Turbo-Cool Sump Update, MV1727A

Drain Plug to Pipe Cap

Figure 1

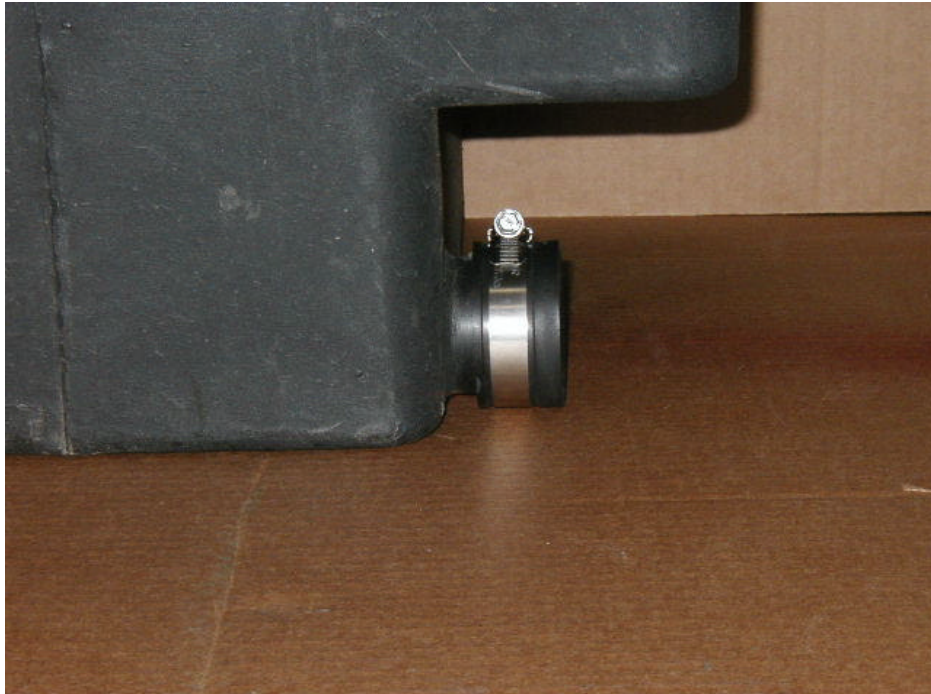
The P/N 38476 1.5" Mechanical Gripper Plug shown in the Turbo-Cool Installation Manual has been replaced with a P/N 47939 1.5" Rubber Pipe Cap.

1. Decide which side of the Sump will be used for the drain and cut off that end. Make cut for one drain only.
2. Slide the 1.5" Rubber Pipe Cap P/N 47939 over the drain outlet and tighten the worm gear clamp until snug (see photo below). Caution: Do not over tighten clamp. Clamp may strip out or collapse the drain tube.
